TOWN OF KILL DEVIL HILLS

Subject: **SITE PLAN REVIEW— 207 W. Martin Street — Proposed Cluster Home Development in the Low Density Residential Zone — Including 10 “3-bedroom” and 11 “2-Bedroom” Long-Term Residential Units**

Subject: **SITE PLAN TECHNICAL REVIEW 2 - 207 W Martin Street in the Residential Low Zone
Proposed Cluster Home Development**

Cover and Index Sheet
 For:
Village West
 Location:
207 West Martin Street
 Parcel in Kill Devil Hills
 Kill Devil Hills Dare County North Carolina

SIZE	PROJECT NUMBER	REV	SHEET NO.
D	226733	-	1 OF 2
CAD FILENAME: 226733		SCALE: 1/4" = 1'-0"

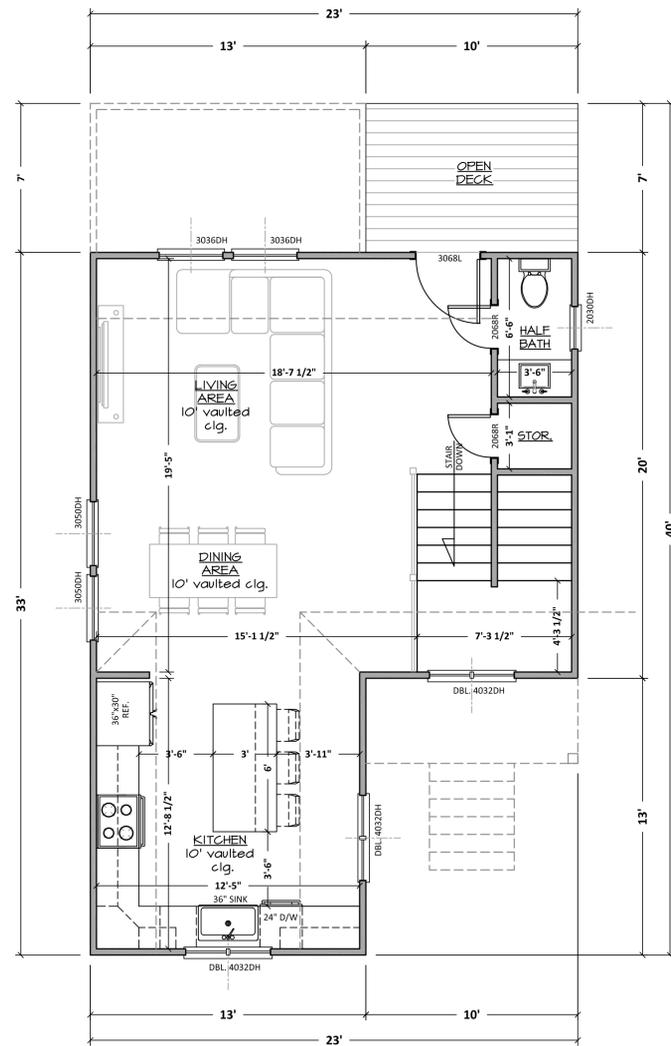
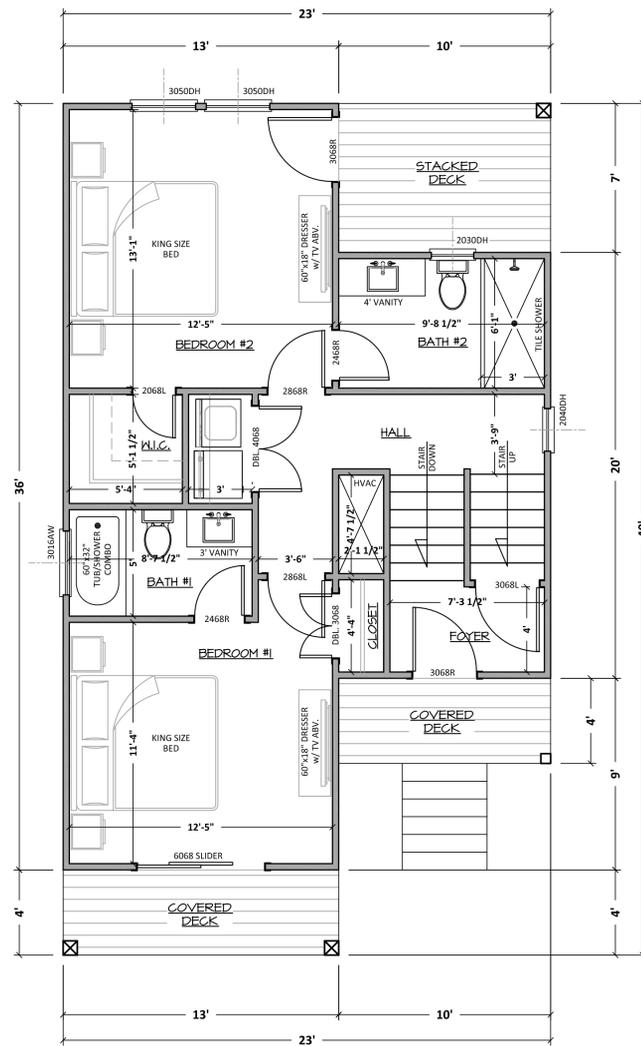
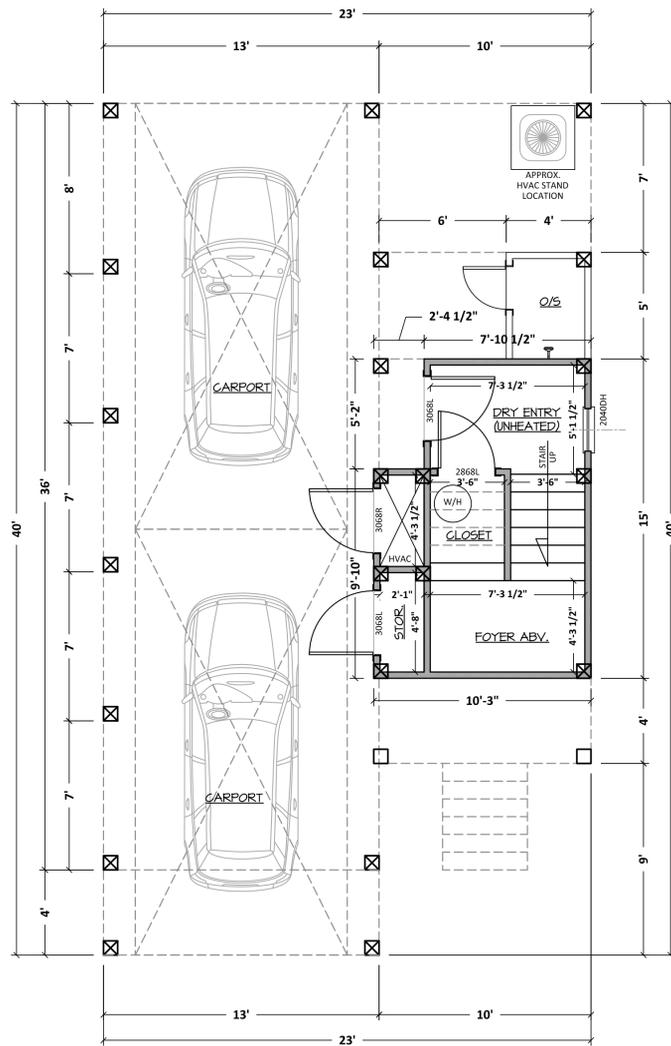
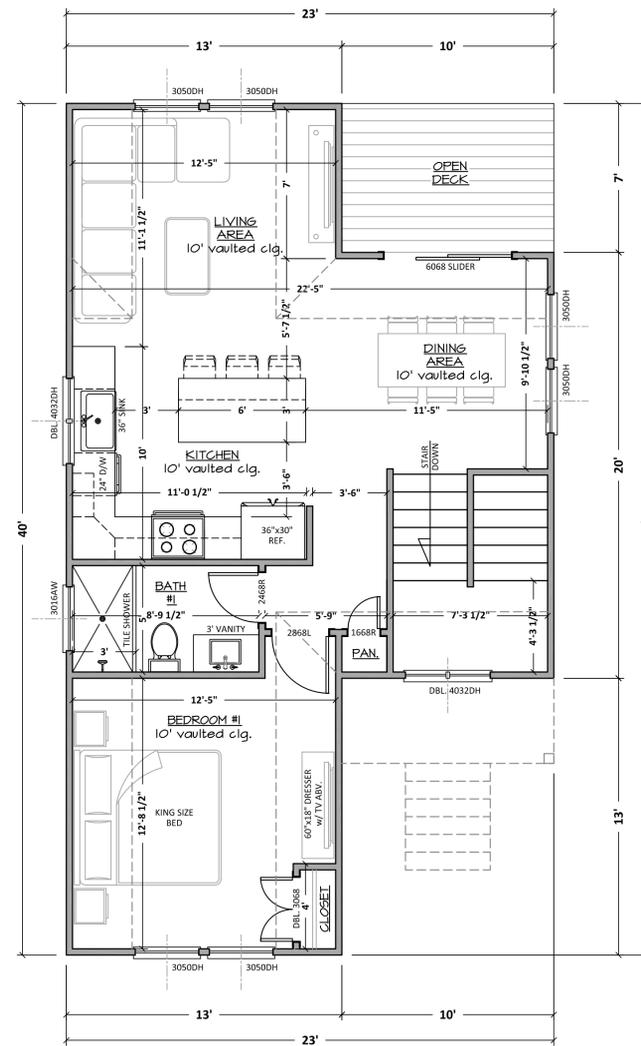
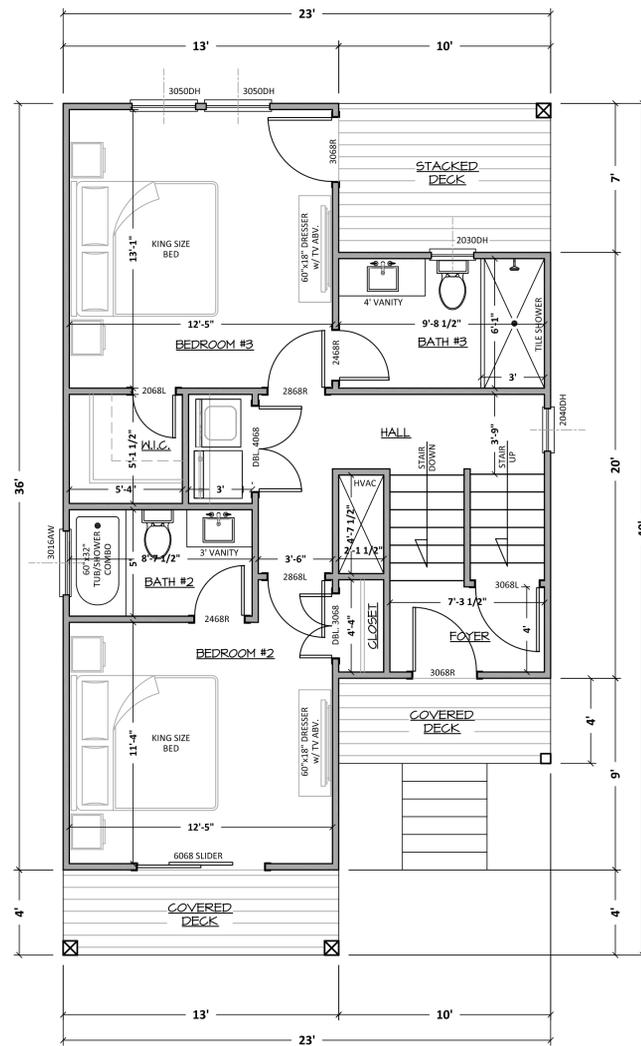
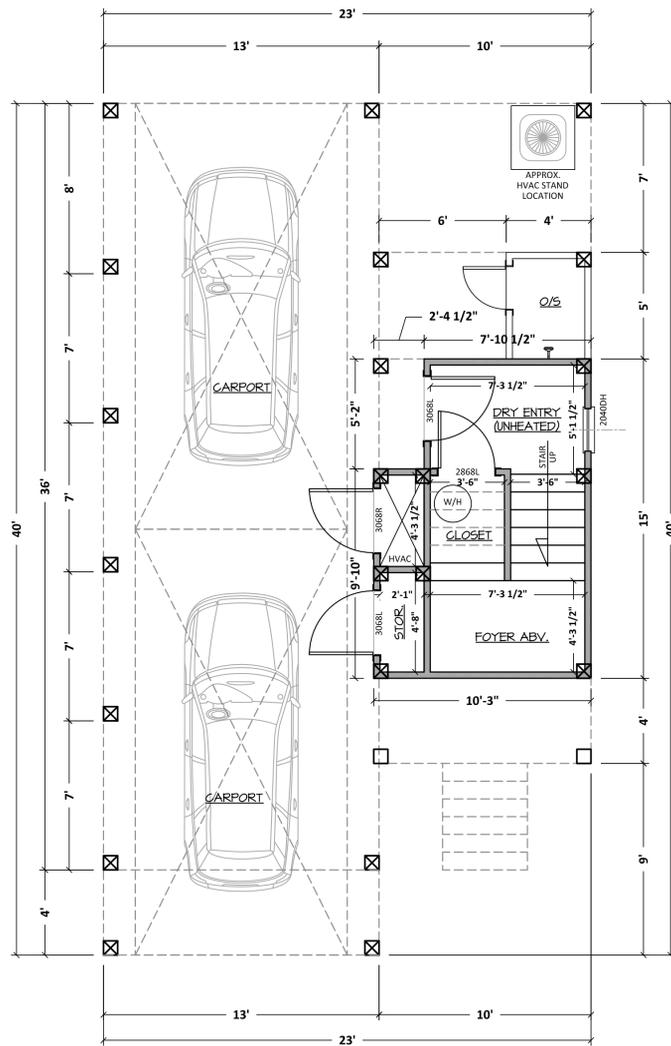
- a. Provide copies of the proposed 3 Bedroom Unit elevation and floor plan. **Print plus error.**
- b. Revise "Bedroom #3" to "Bedroom #2" on proposed 2 Bedroom Unit. **Architect revised**
